CITY OF ALBUQUERQUE
PLANNING DEPARTMENT
DEVELOPMENT REVIEW BOARD

Project# 1005033

**CITY OF ALBUQUERQUE
PLANNING DEPARTMENT
February 27, 2013
DRB Comments**

RE: Tract 84E, MRGCD Map #35

SP-01
sheet of sheets

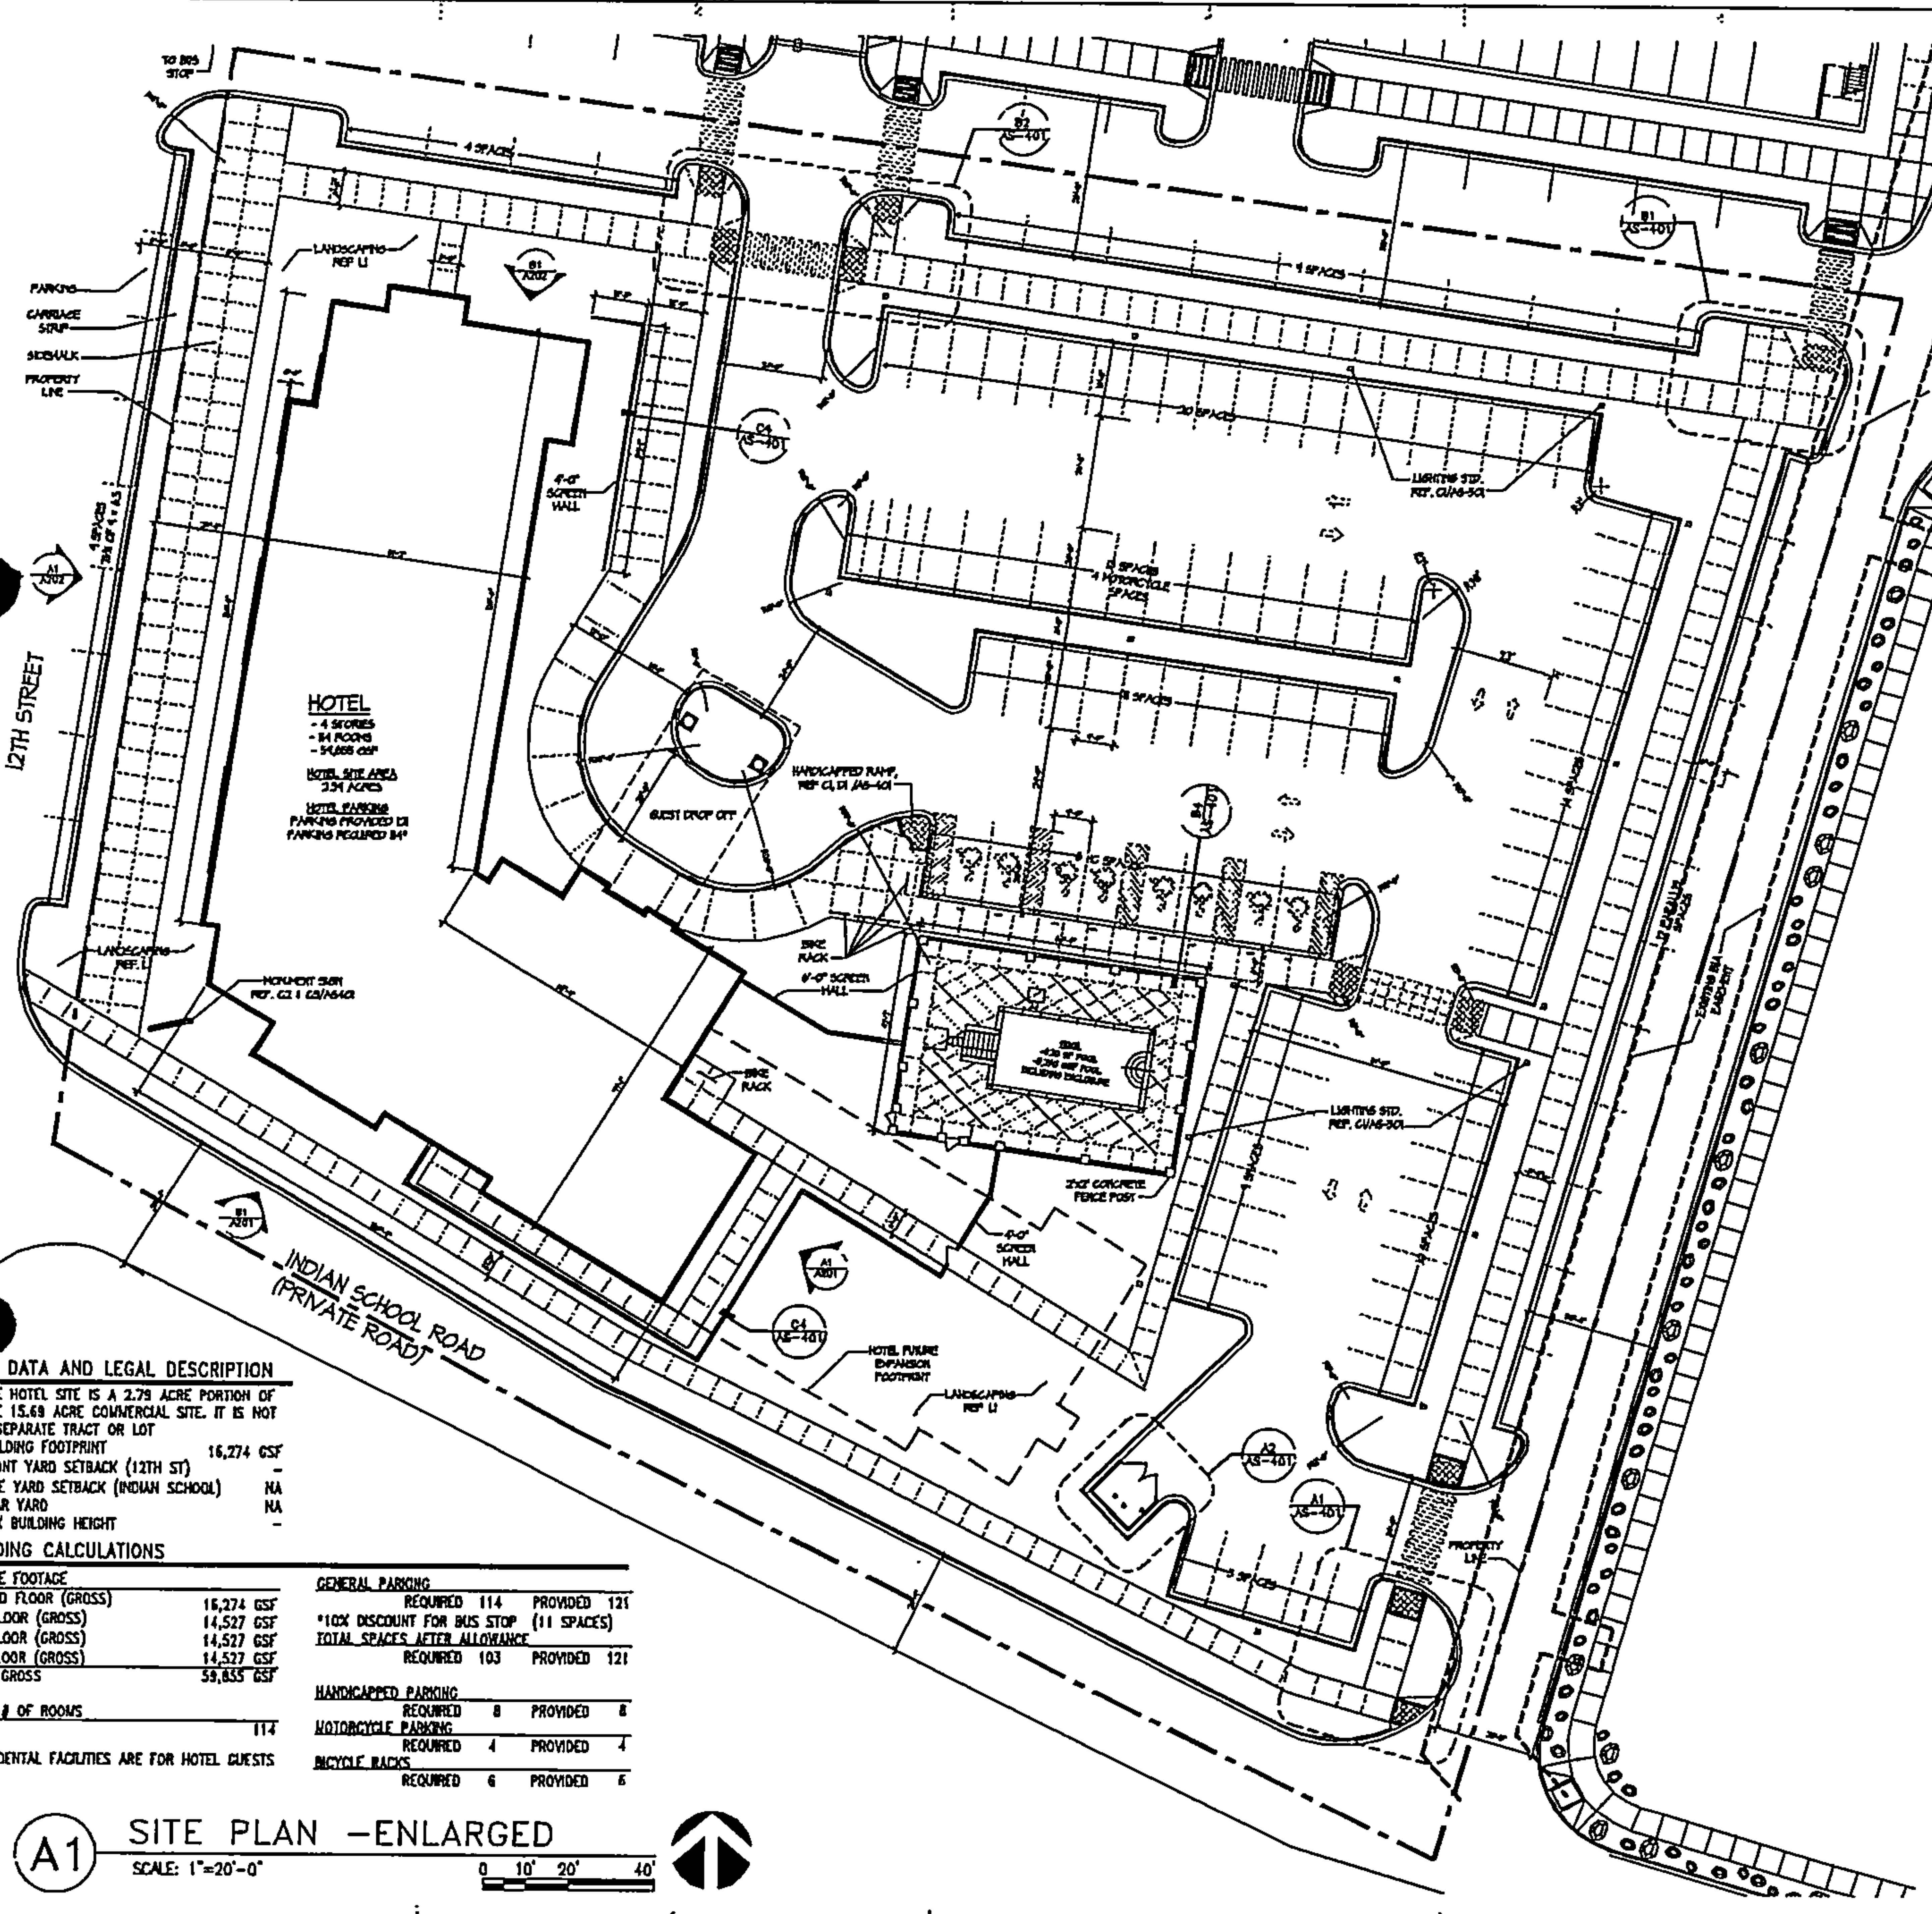
1. The new Sheet SP-1 should be titled "Site Plan for Building Permit". This indicates that this is the actual site plan to be approved for this project.

2. The Site Plan Sheet SP-1 shows Indian School Road as a private road. Why is it designated this way? The City has maintained this portion of Indian School for many years. A private road designation means, for one, that the City does not have to maintain it any longer.

3. Sheet SP-1 indicates the hotel site is separated by property lines from the remaining portion of the commercial property. This will require a replat of the property. Planning will take delegation of the approved site plan until the replat is approved by DRB.

4. What is the purpose of the "existing BIA easement" shown on Sheet SP-1?
5. The Landscape Plan shows 13 Ash trees proposed mainly for street trees. Because of the high water usage of Ash trees, Chinese Pistache or Japanese Pagoda or some other lower water use tree are a better choice.

8. Existing & proposed easements must be shown on sheet SP-1 & the Landscape Plan.
9. The overall width of the elevations are not shown.
10. Sheet L1 should be titled "Landscape Plan".

Concur. Sheet SP-02 will be resubmitted.

C2 MONUMENT SIGN DETAIL
SCALE: 1/4"=1'-0"

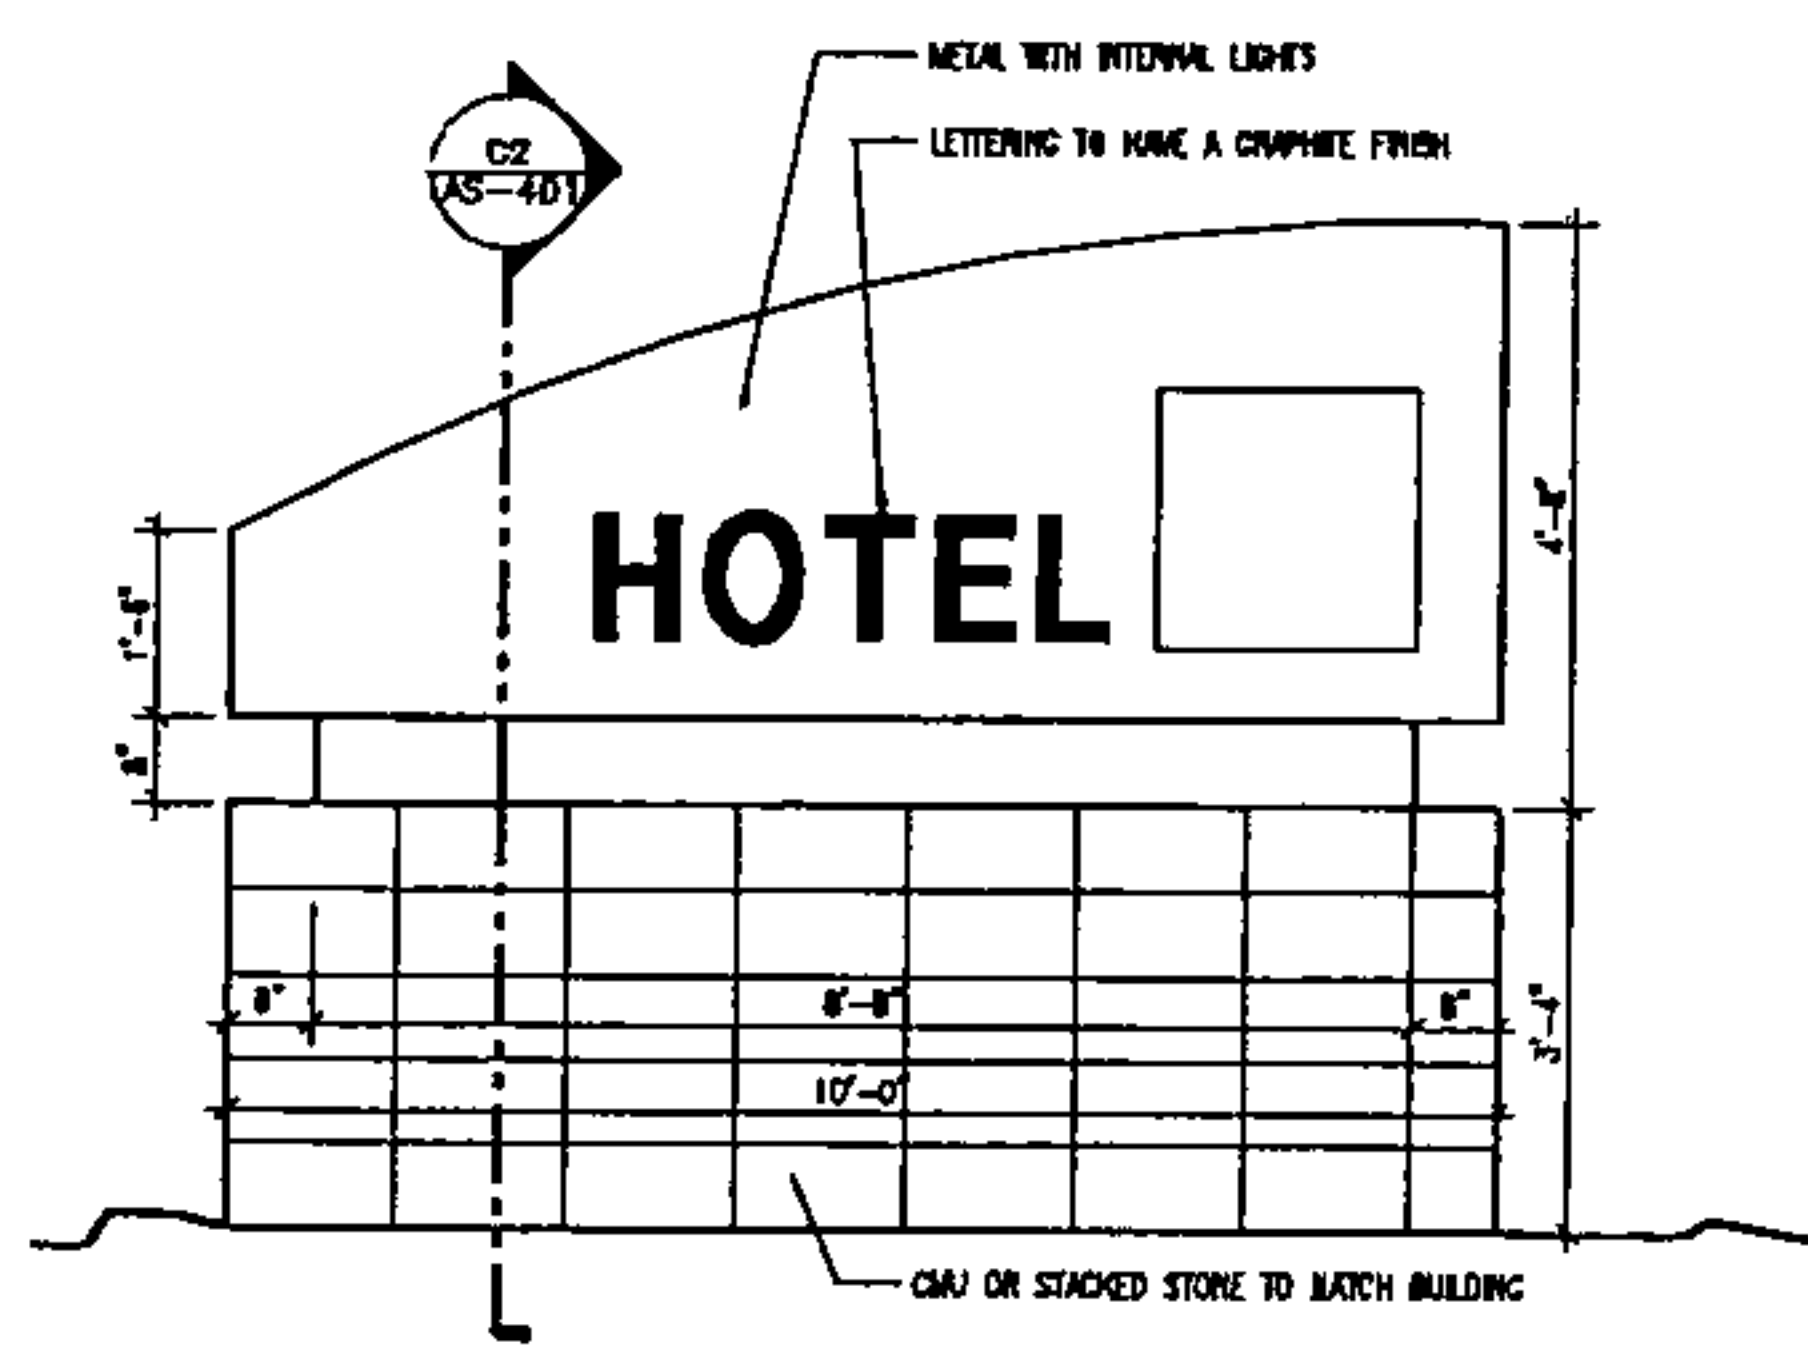
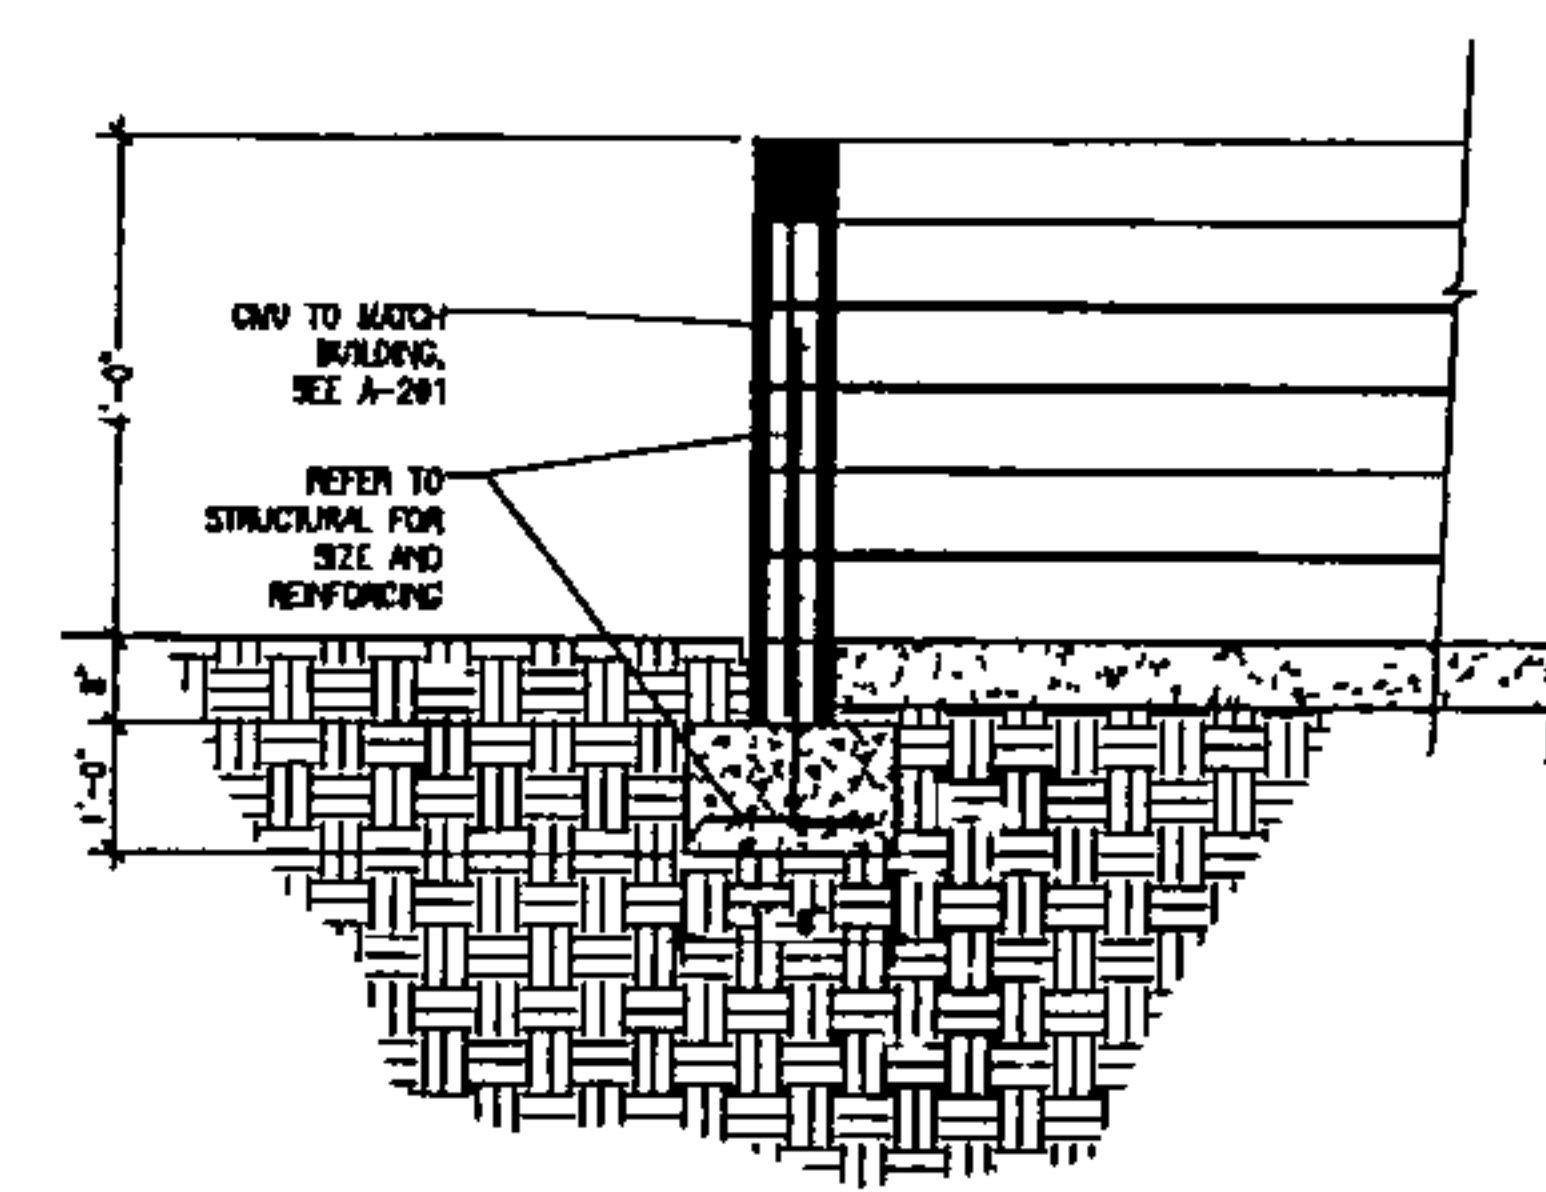
There is a monument sign placed in the location for future sidewalk which is not consistent with the approved site plan and needs to be relocated as a condition of SIA extension.
